CHATSWOOD TO SYDENHAM
**SYDENHAM STATION
AND SYDNEY METRO
TRAINS FACILITY SOUTH
MODIFICATION
SUBMISSIONS REPORT**

Purpose of this report

During public exhibition of the modification report, 15 submissions were received by the Department of Planning and Environment. The Secretary of Department of Planning and Environment provided copies of the submissions to Transport for NSW.

Figure 10 PMF velocity change with modification

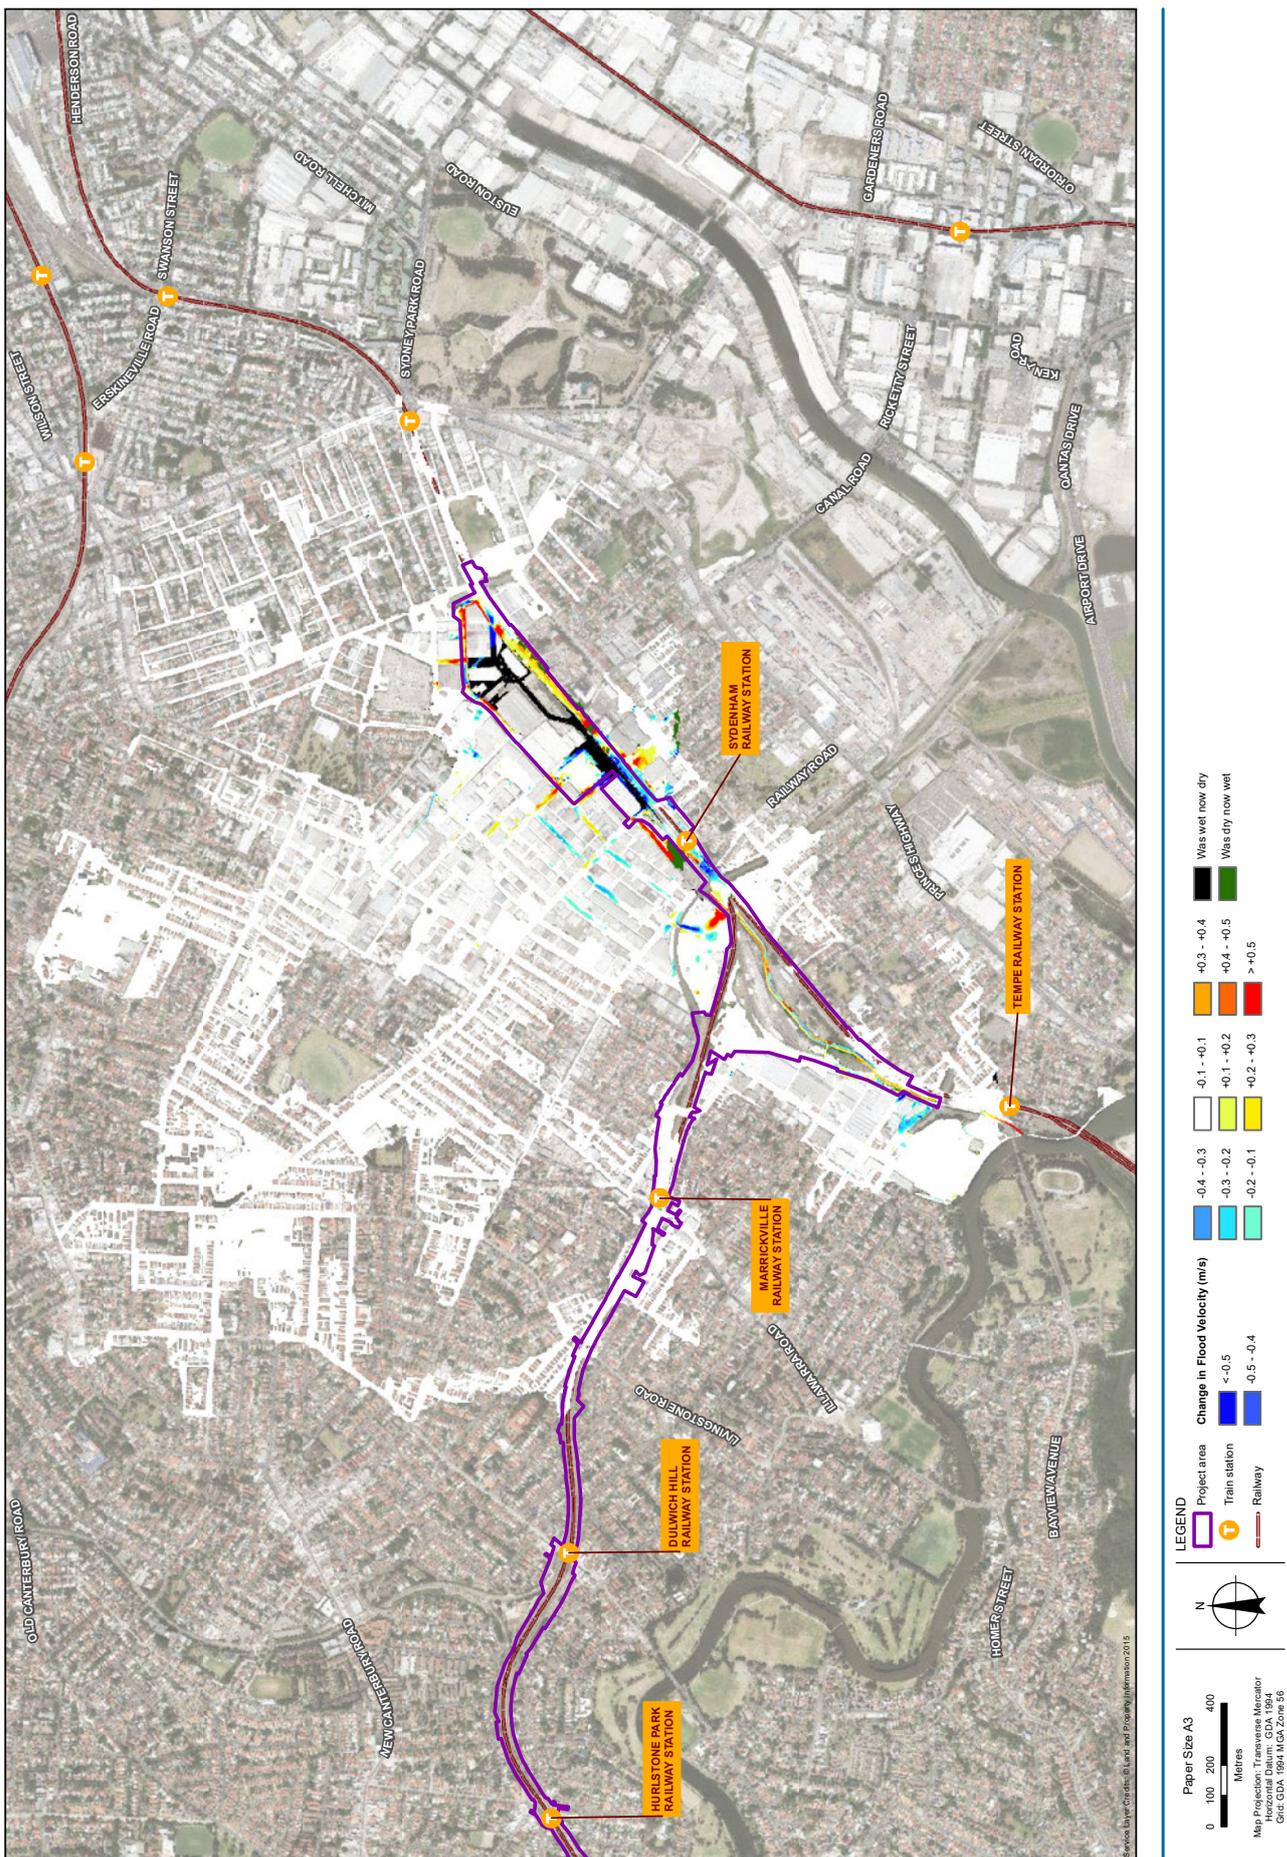
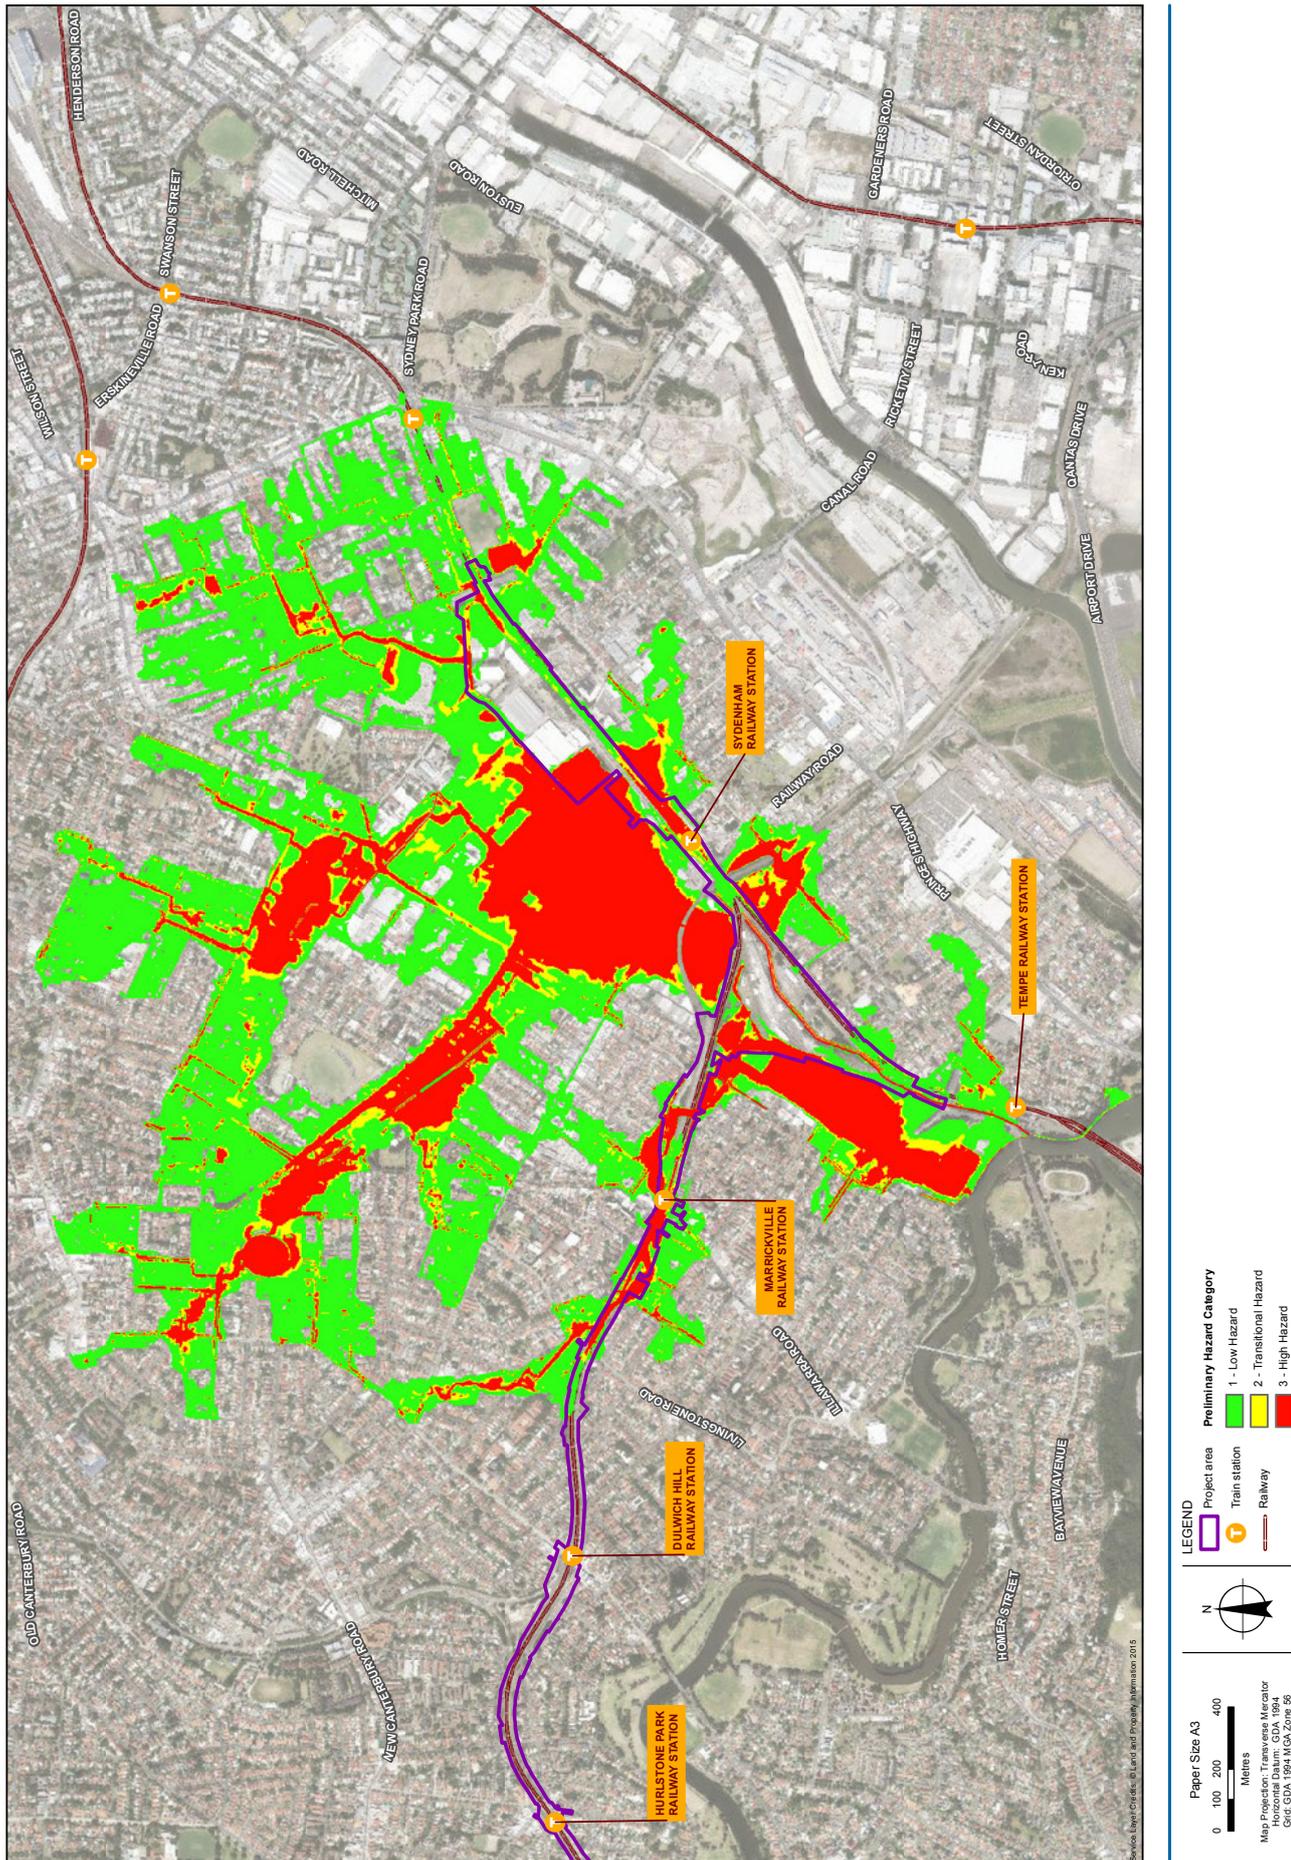
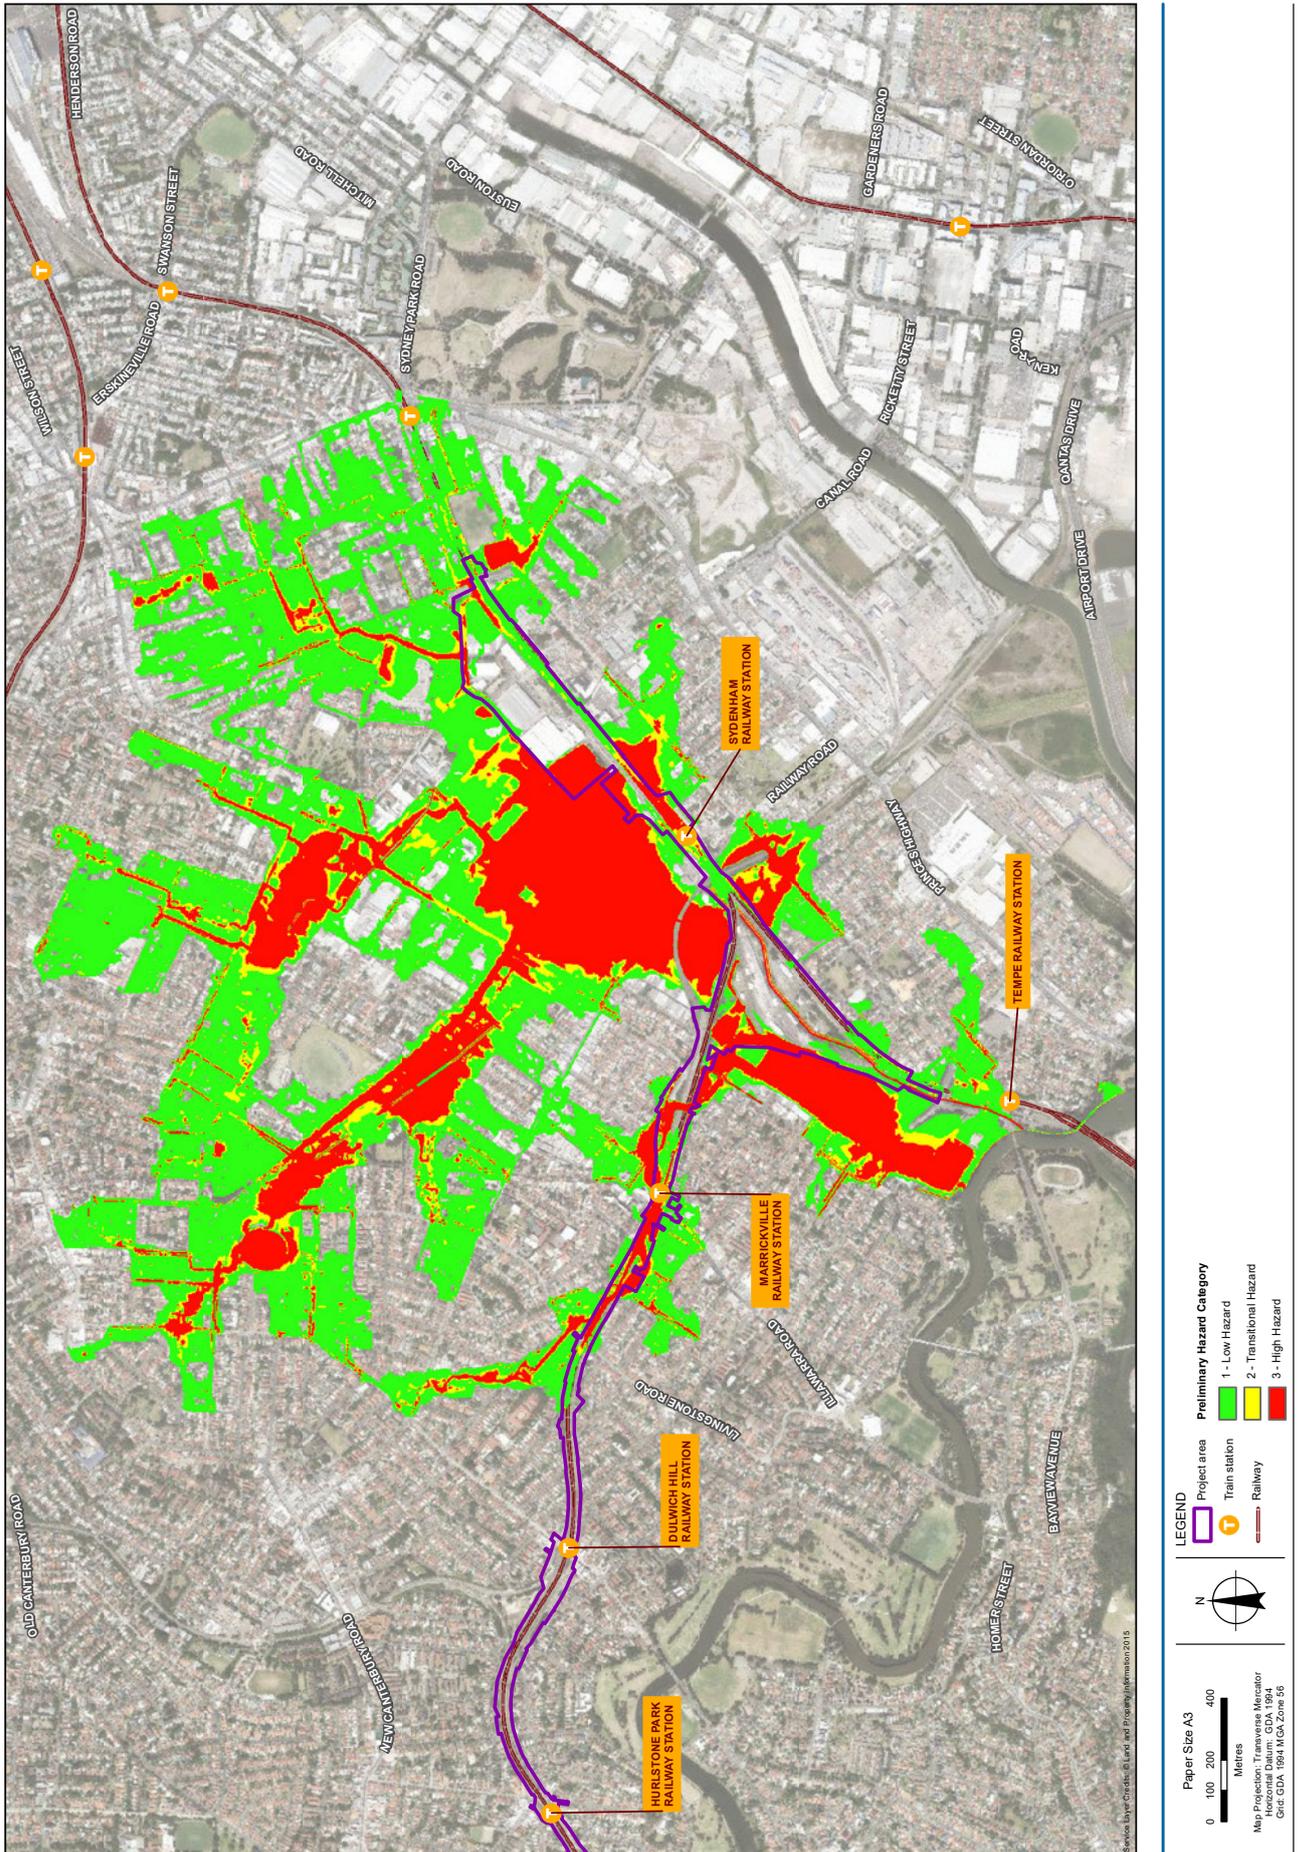
The modification report indicates that the modification will result in increases in flood depth and extent in the vicinity of Frederick and Sutherland streets. From a floodplain risk management perspective, it is prudent that the proponent adequately investigates the following:

- Identify additional properties that would be affected by over floor flooding in 1 per cent annual exceedance probability, which in existing conditions are subject to ground flooding only
- Identify additional properties that would be within the flood planning area, which are currently above the flood planning level
- Identify additional properties that would become flood affected due to the increase in the probable maximum flood extent
- Identify the potential for increase in flood damage due to the above points
- Address impacts on emergency management planning
- Undertake a consultation process with affected property owners and Inner West Council.

The modification report identifies that, with the proposed drainage and flood improvements in place, flooding impacts with the proposed modification would generally be less than those identified for the approved project. Notwithstanding, there is predicted to be an increase in flood depths in some locations, including on Sutherland and Fredrick streets. Additional technical information relating to the flooding assessment is provided in Appendix C.

- The one per cent AEP plus 10 per cent flood level change
- The one per cent AEP plus 10 per cent velocity change
- The one per cent AEP plus 10 per cent provisional flood hazard
- The PMF flood level change (as was provided in the modification report)
- The PMF velocity change
- The PMF provisional flood hazard.

This additional mapping does not change the outcomes of the flooding assessment provided in the modification report. Additionally the mitigation measures, which provide a performance standard for the project, would continue to apply.
